Technical Guidance Committee Meeting

Draft Minutes

Thursday, February 6, 2014

Figure 4-33. Design dimensions for use with the sand mound design checklist.

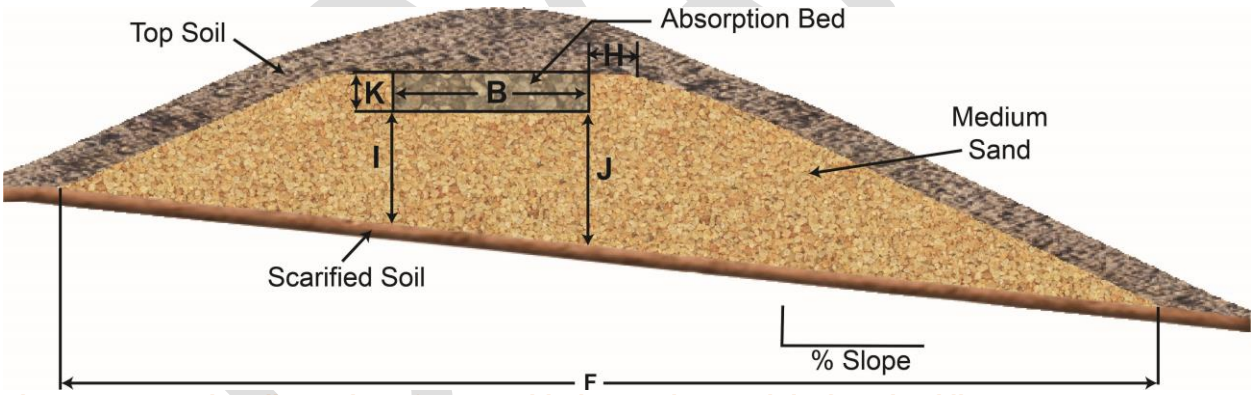
1. Move H in Figure 4-33 to a more visible location on the figure.
2. Adjust the design checklist and add back in items 7 and 8.
3. Look into suggested ripping/scarification widths and depths.
4. Move the 15 foot description in Figure 4-34 so it is not split by the arrow and make this dimension a minimum.
